1 **REVISED PER ADDENDUM No. 1 DATED APRIL 21, 2011**

BRIDGE NO. 12E0003
POST MILES 33.0

RETAINING WALL No. 2
GENERAL PLAN

BIDWELL PARK VIADUCT (WIDEN)
GENERAL NOTES

BIDWELL PARK VIADUCT (WIDEN)
TYPICAL SECTION No. 4

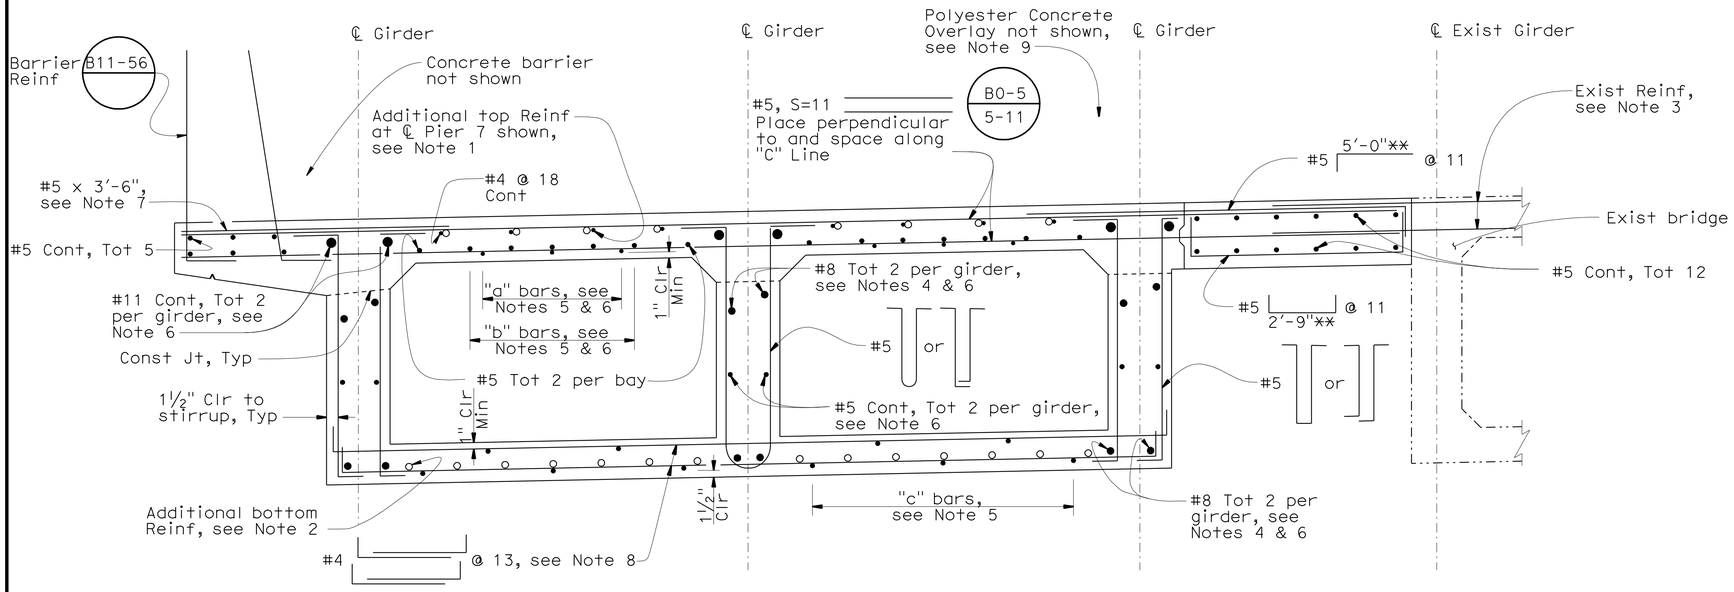
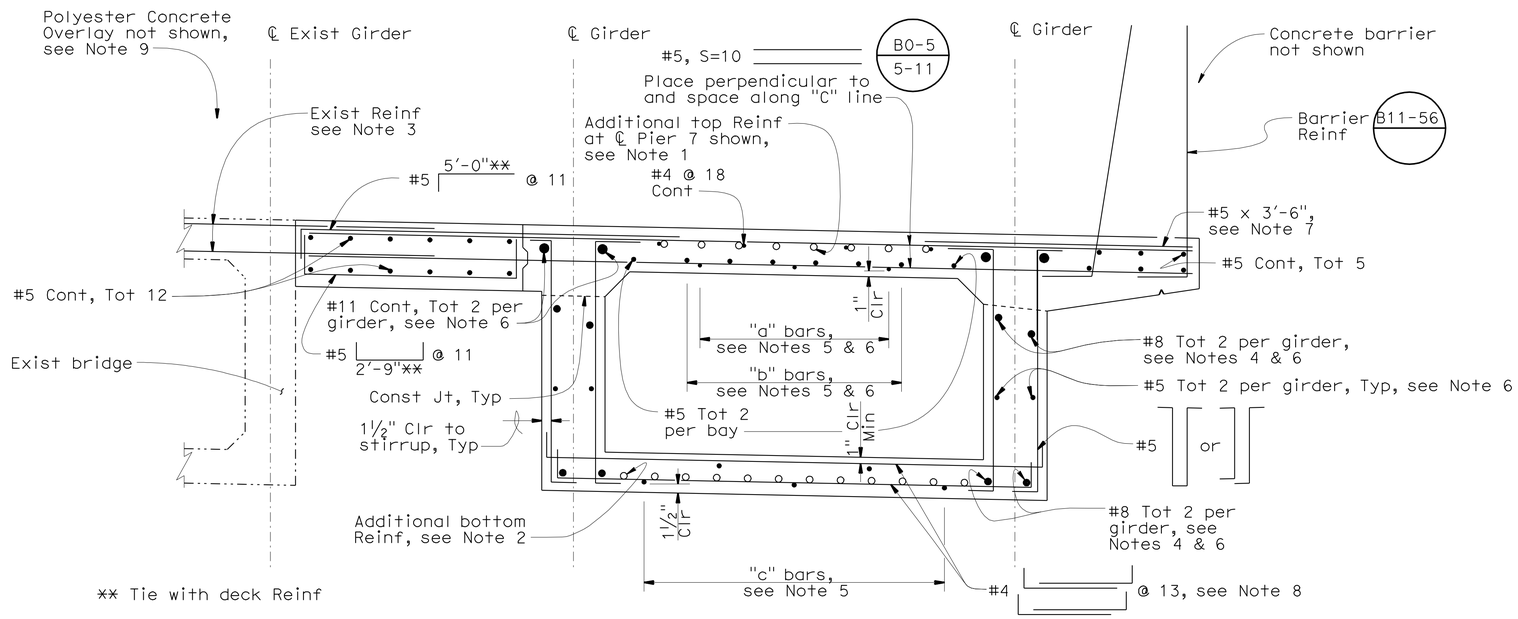
8. Place #4 transverse soffit reinforcement from Abutment 1 to Pier 11 of both Left Structure and Right Structure.
9. Polyester Concrete Overlay not shown. Prepare Concrete Bridge Deck Surface and overlay full deck width (new and existing structures including approach slabs) with 3/4" minimum and varies Polyester Concrete. For limits, see "Constuction Sequence No. 3" sheet. 1

LIMITS OF PREPARE CONCRETE BRIDGE DECK SURFACE AND POLYESTER CONCRETE OVERLAY

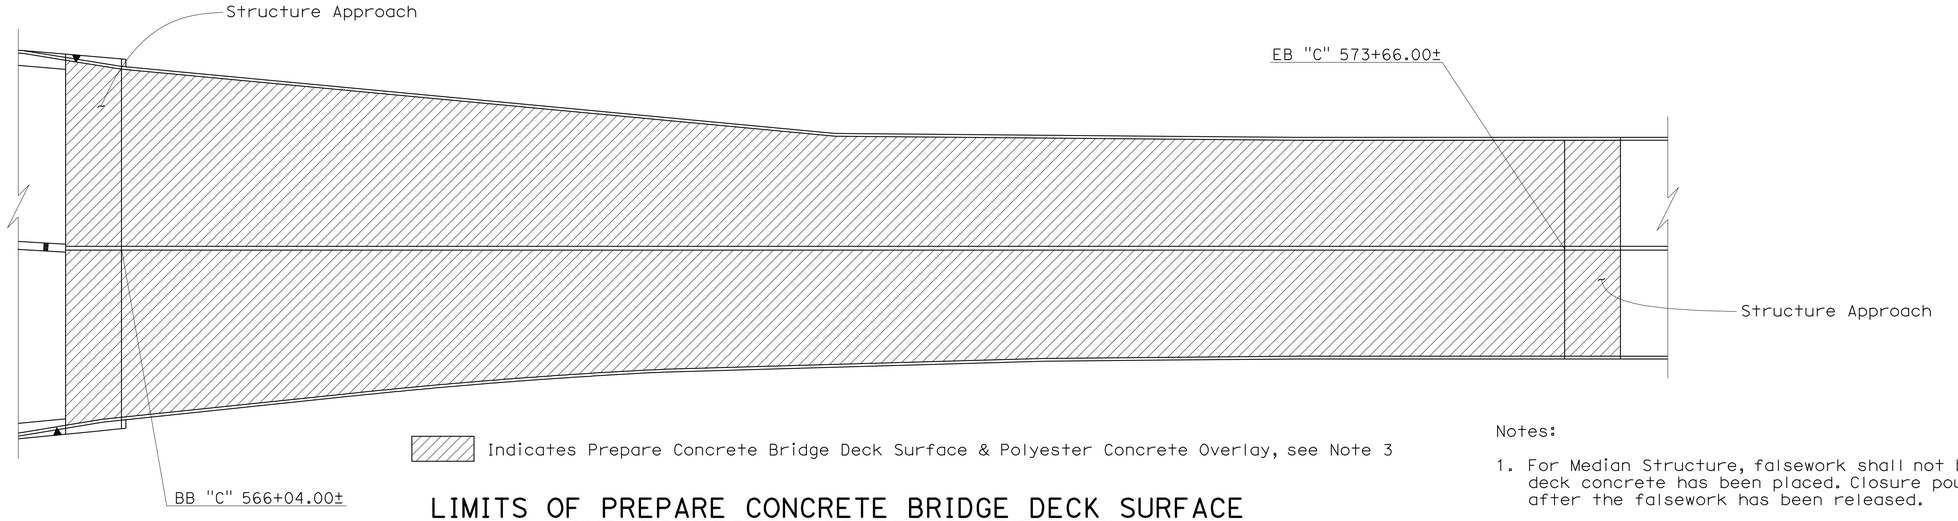
1. For Median Structure, falsework shall not be released less than 28 days after the deck concrete has been placed. Closure pour shall not be placed sooner than 14 days after the falsework has been released.
2. For Left and Right Structures, falsework shall not be released less than 28 days after first deck pour has been placed. The second deck pour and closure pour shall not be placed sooner than 14 days after the falsework has been released.
3. (1) Prepare Concrete Bridge Deck Surface and place Polyester Concrete Overlay (3/4" mininum and varies thickness) on full width of structure, barrier to barrier, including approach slabs. Place Polyester Concrete Overlay after completing all bridge barriers.
